P 520894

**ON-SITE SEWAGE DISPOSAL SYSTEM**  
**HOWARD COUNTY HEALTH DEPARTMENT**  
**BUREAU OF ENVIRONMENTAL HEALTH**

ADDRESS: 6522 River Clyde Drive

TRENCHES:	Trench to be _____ feet wide. Inlet _____ feet below original grade. Bottom maximum depth _____ feet below original grade. Effective area begins at _____ feet below original grade. _____ feet of stone below distribution pipe.
LOCATION:	
PURPOSE:	Existing septic system has failed. Call for inspection when ground is opened so sanitarian can recommend repair.

P520894

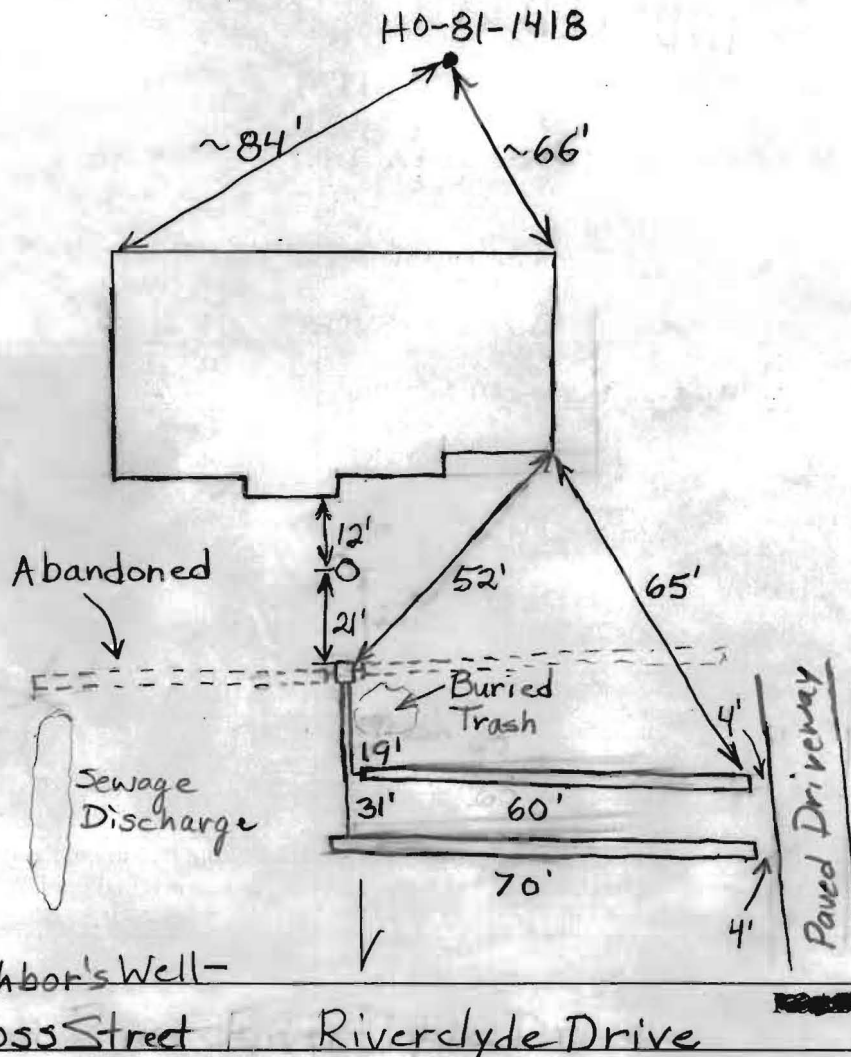
PRE-CONSTRUCTION 9/21/04 To install two trenches below the pile of buried trash. Should be able to squeeze in 2 - 65' trenches.

INSTALLATION O.K. to stay connected to old trench above the trash pile. Abandon the old trench on the left side off the yard that has sewage seeping out of it. (BB)

10/5/04 System installed per specifications. (BB)

# SITE PLAN

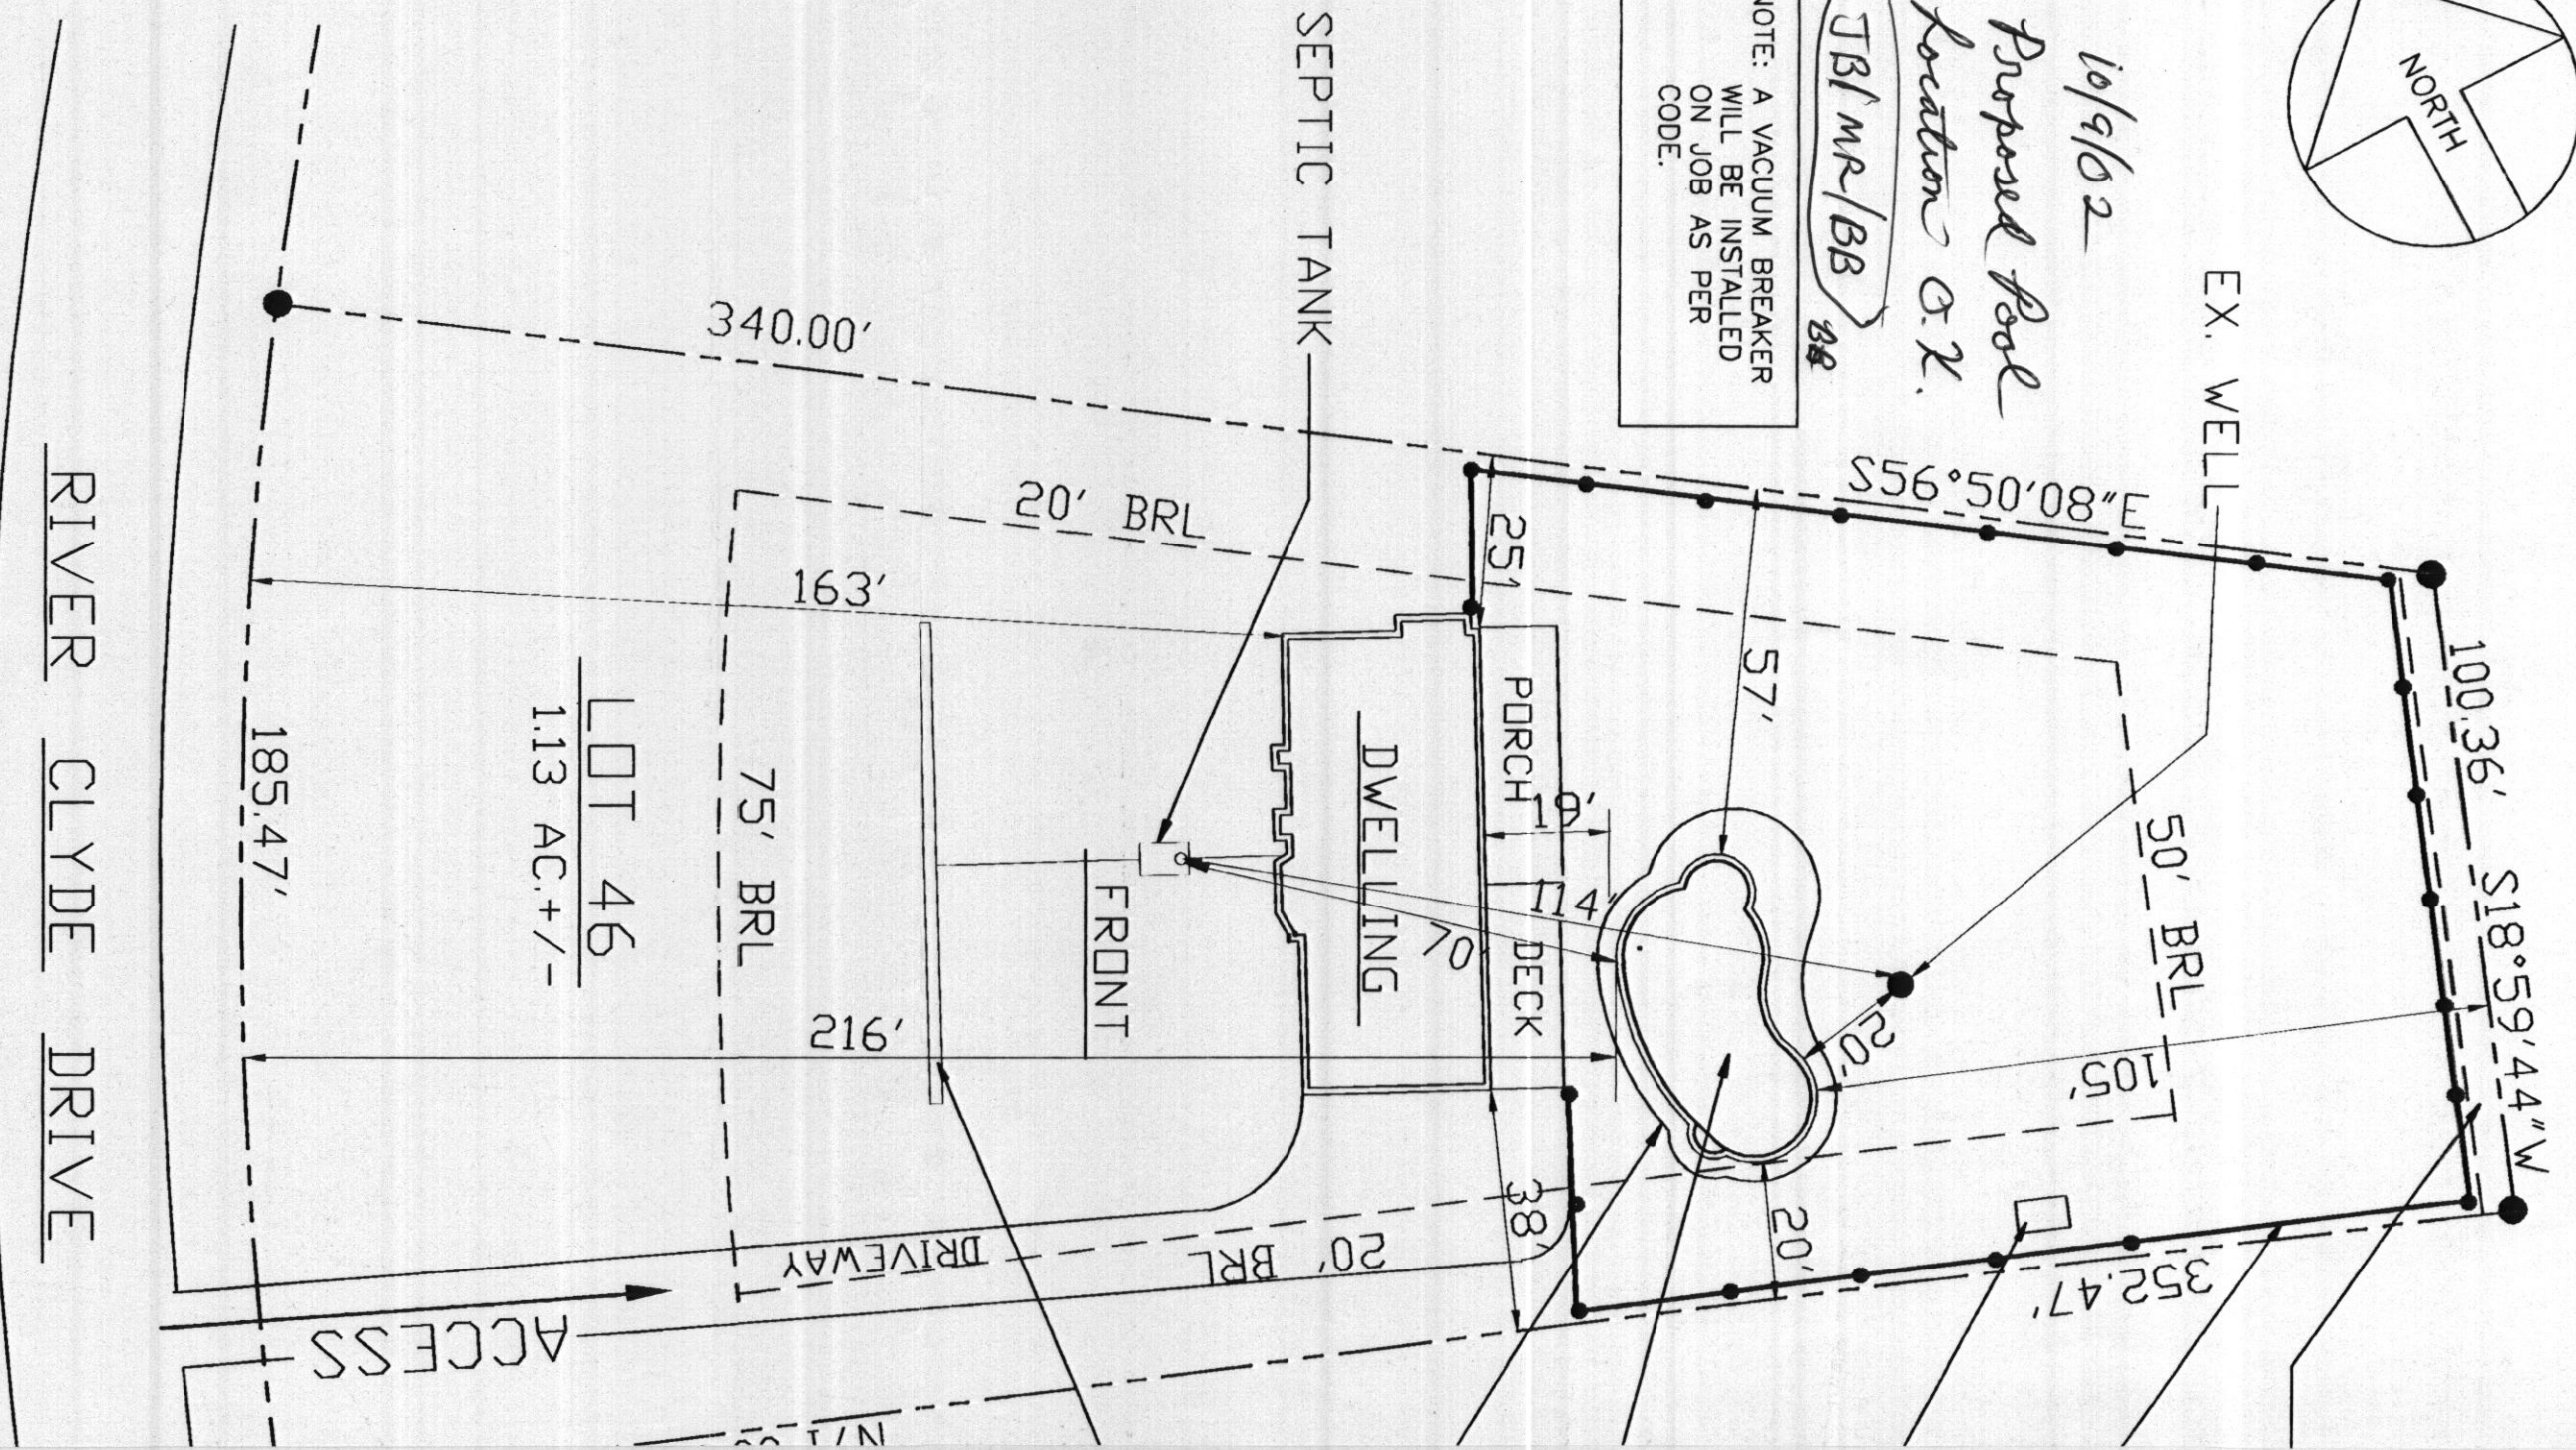
10/9/02  
Proposed Pool  
Location O.K.  
JBI/MR/BB
